City of Raleigh

COA-0004-2020

206 LINDEN AVE

APPLICATION FOR A CERTIFICATE OF APPROPRIATENESS – STAFF REPORT

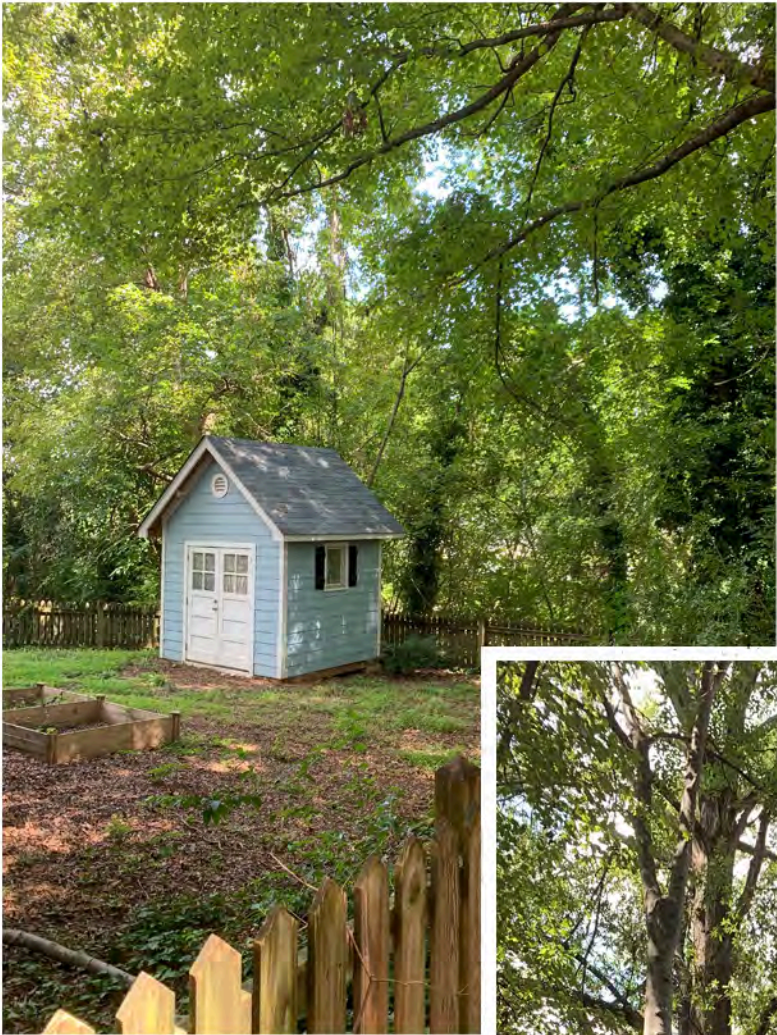
1. Please provide a detail photograph of the one original window. Do you plan to reinstall the original window on another façade?

2. The written description states that some of the windows are aluminum. Besides the one original window, what other window types/materials are present?

A lot of the windows look like this one - the trim is pushed back from the face of the siding, trim has been patched in several places + new inner trim is proud of the older trim, and a single board is popped out under the window and painted the color of the siding. All windows are not original but one and very in material.

On further inspection, we do not think any of the existing windows are original. There are two that look like they have been salvaged possibly from another house when they were dropping the ceilings. They are one over one wood windows, but from the interior you can tell that they are smaller windows than the original rough-opening. They have added to the trim/casing around the windows to make them fit in the rough-opening. One is on the rear elevation and the other is in the same room but on the side elevation, the glass has been replaced (there is a sticker for the glass) and the sashes are not the same height so it has been modified to fit. Both of these wood windows have sashes that now run on an aluminum track. See Pics below.

Most of the windows that were replaced are wood windows with vinyl/fiberglass frame (a replacement insert that would be slightly smaller than the original window) most replacements are double glazed aluminum/vinyl windows with wood trim

206 Linden Ave - New Built To Open Space

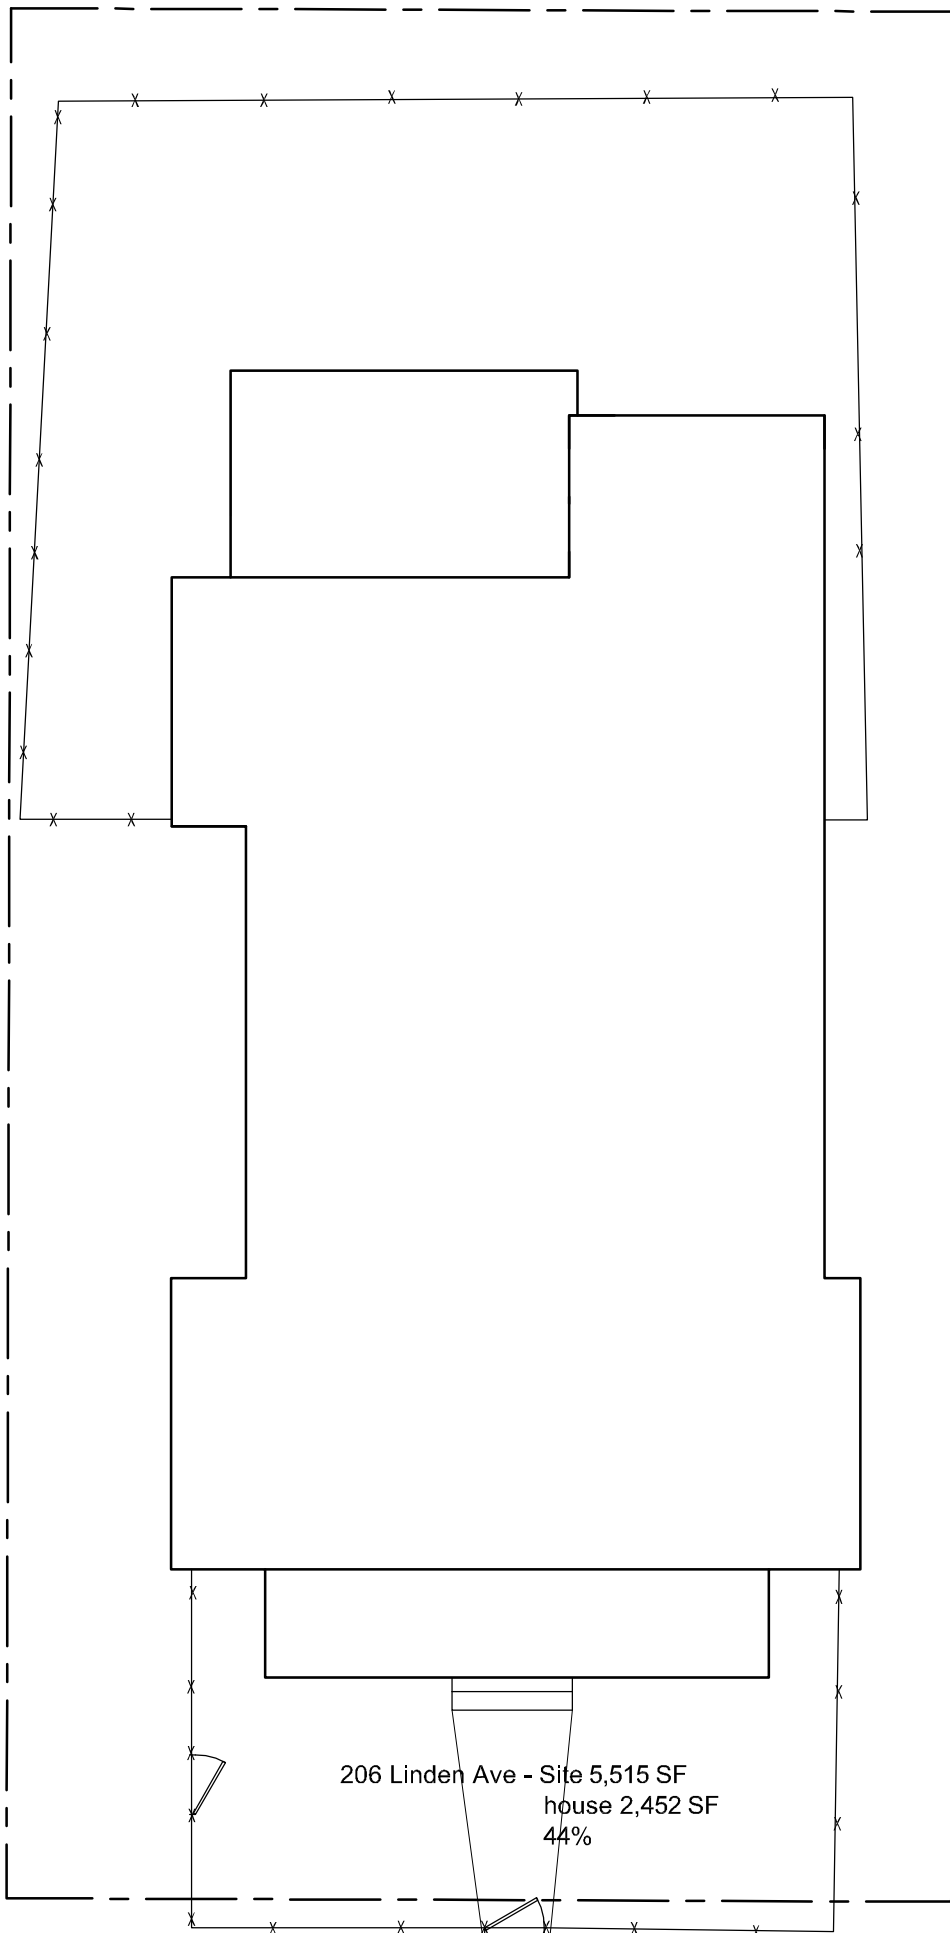
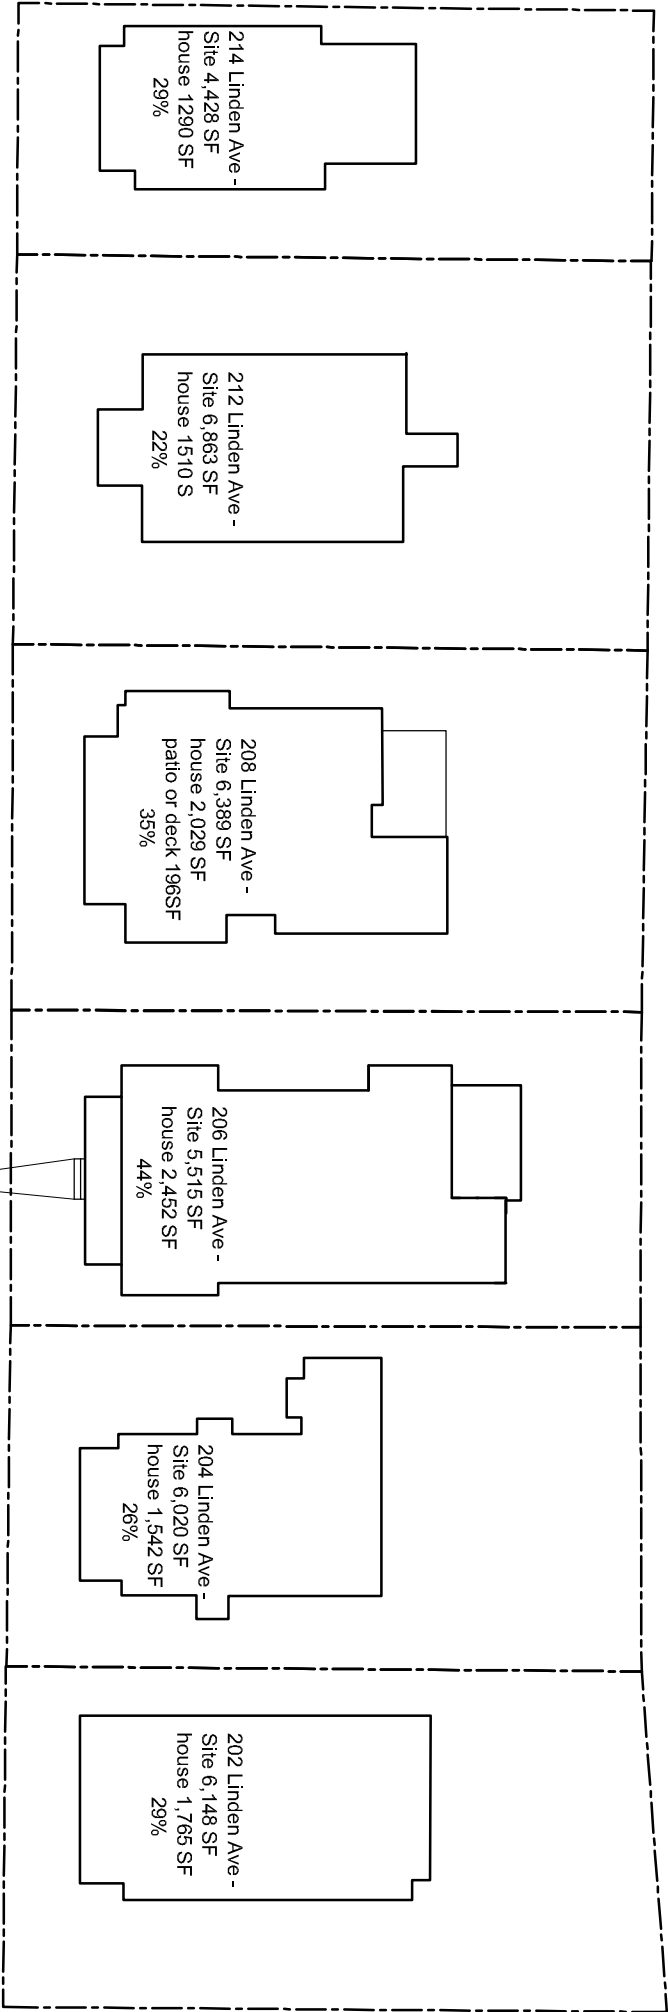
- 17* **Built mass to open space analysis:** According to the applicant, the lot is 5,515 SF. The original built mass including the footprint of the house and a historic shed that is no longer extant is 1,657 SF. The original proportion of built mass to open space was 30%. The footprint of the proposed built area is 2,452 SF. The proportion of built mass to open space is proposed to be 44%.

206 Linden Ave - New Driveway Side Elevation

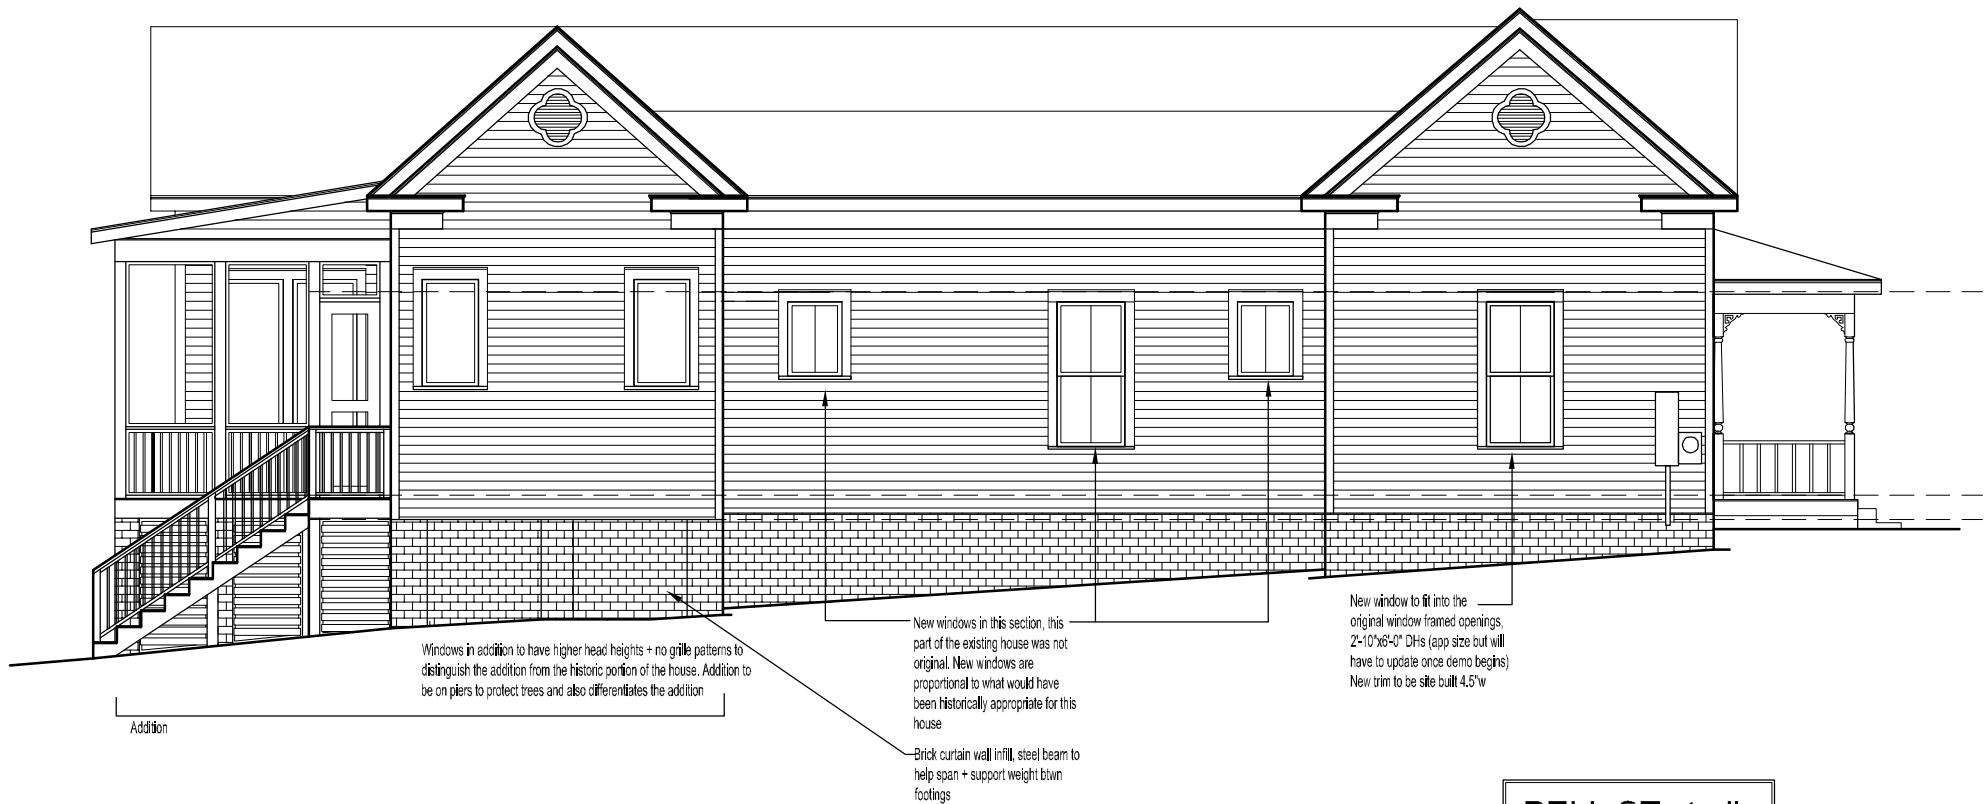
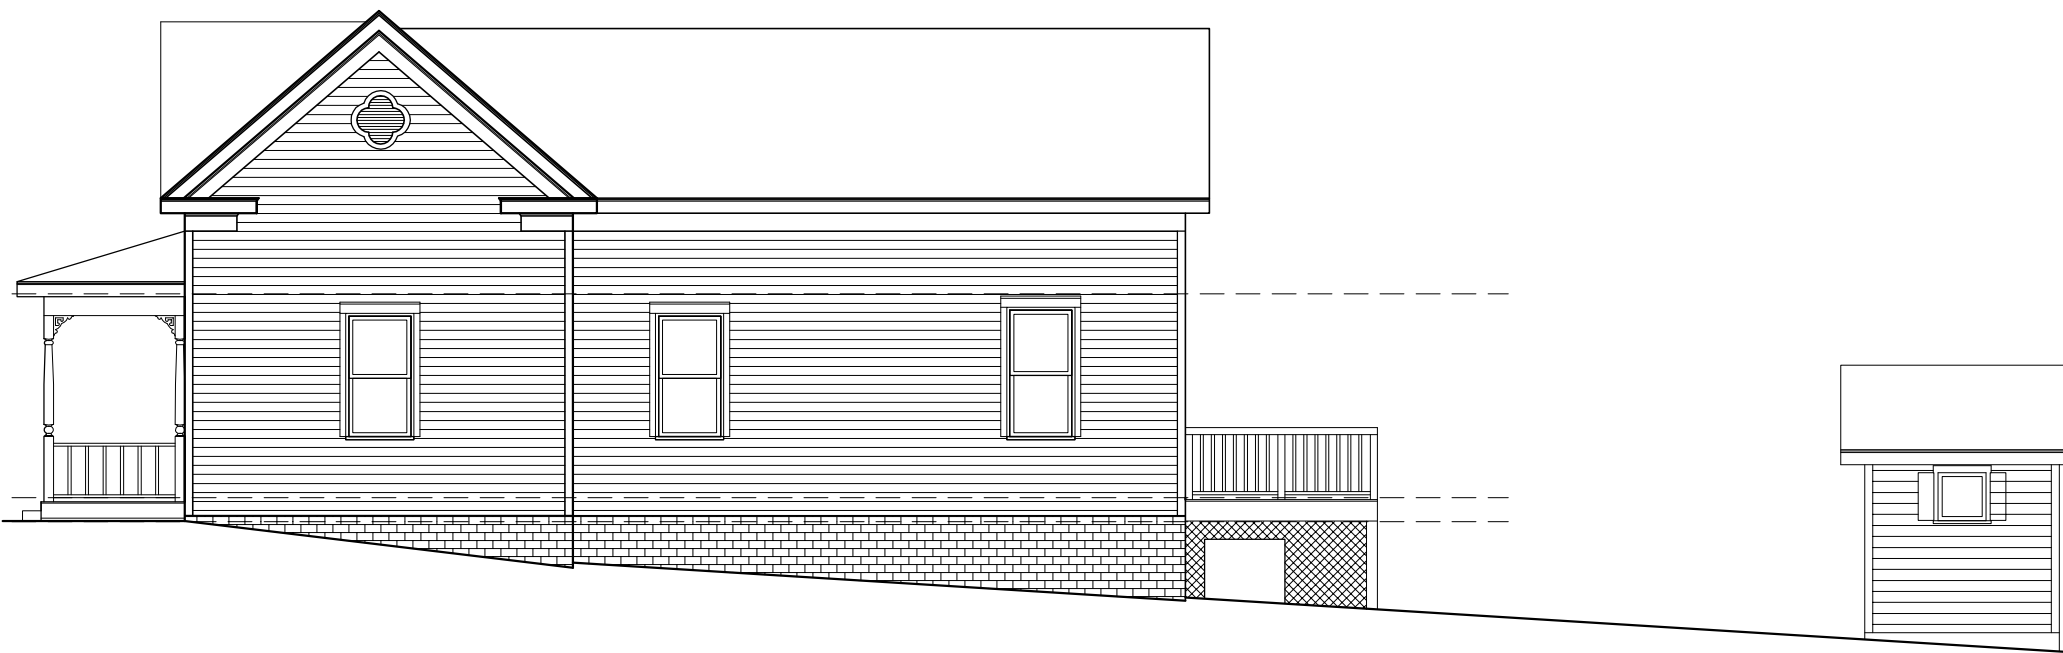
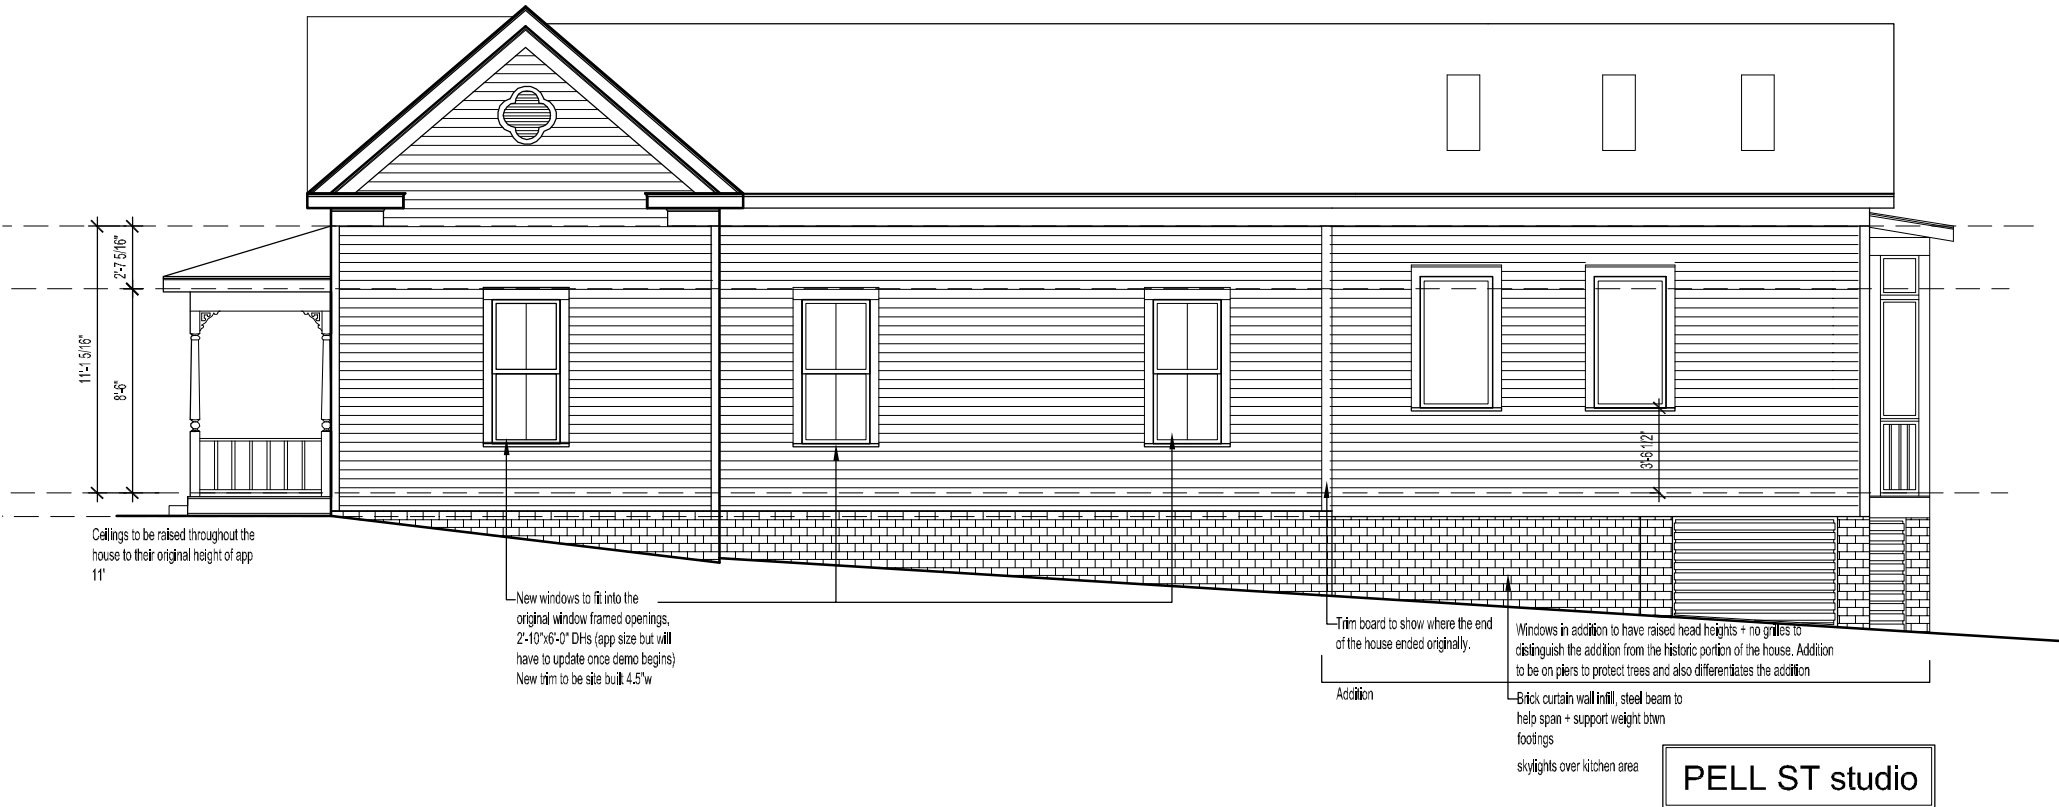
- 6* As shown in the side elevations, the roof ridge of the addition will be lower in height than the roof ridge height of the historic house. The elevations were not dimensioned.
